SERVICE BULLETIN

Service Bulletin No.: DAC1-33-05 Rev 0

Title: Installation of RFI protected Lighting
Voltage Regulator Assembly

VIEW: LOOKING DOWN (LH SIDE)

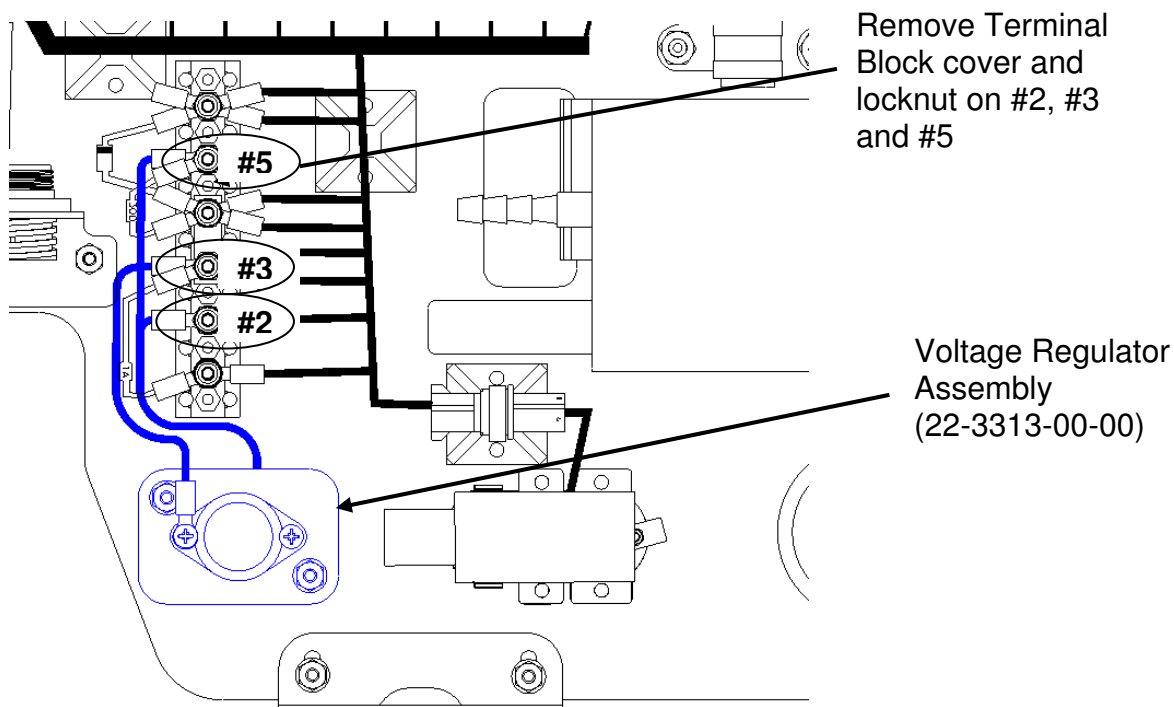
- 10.1** Disconnect the aircraft battery as per AMM Chapter 24-31-00
- 10.2** Remove the instrument panel cover as per AMM Chapter 25-10-00
- 10.3** Pull the Battery Circuit breaker located on the right side of the instrument panel.
- 10.4** Disconnect the Garmin display and Garmin air data computer connectors.
- 10.5** Remove the terminal block cover and voltage regulator assembly (22-3313-00-00) from the aircraft.

Note: Cooling fan hose may need to be temporarily disconnected from fan. Use a twisting/pulling motion to disconnect.

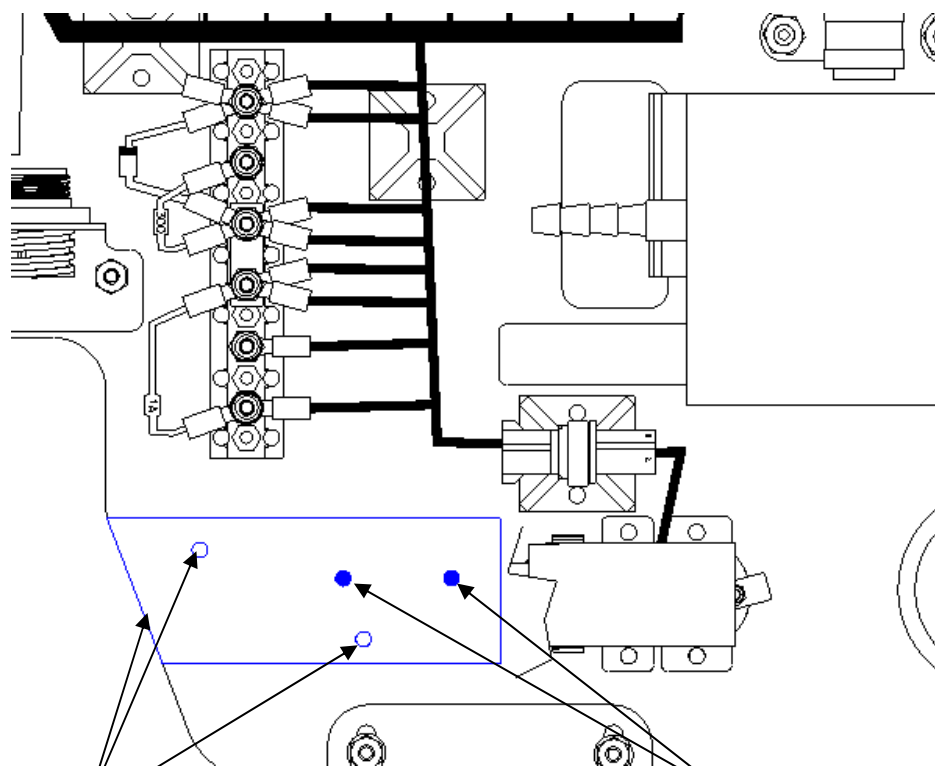
10.6 Print template to scale (see Appendix A).

10.7 Place template over existing voltage regulator holes and drill additional holes using a 5/32" drill bit.

Line template with existing voltage
regulator holes and edge of
instrument panel

Drill holes with
5/32 drill bit.

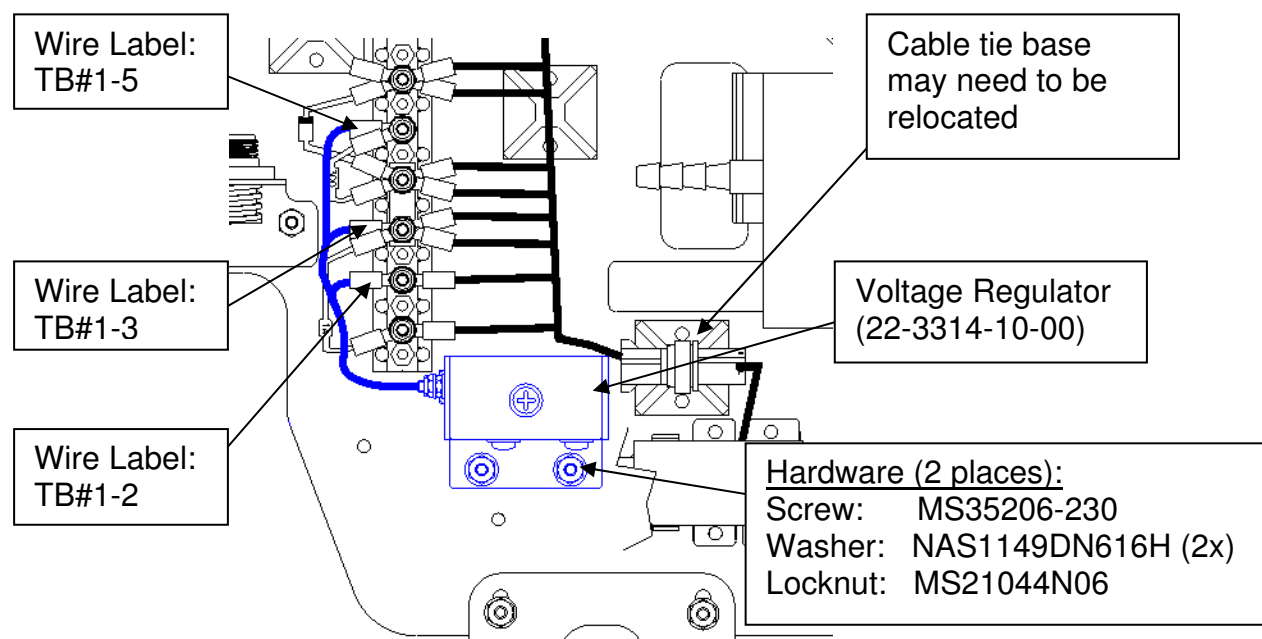
- 10.8** Install new voltage regulator assembly (22-3314-10-00) using supplied hardware. Use existing terminal block hardware for wire connections.

Note: Cable tie base may need to be relocated. Additional cable tie base supplied, if needed.
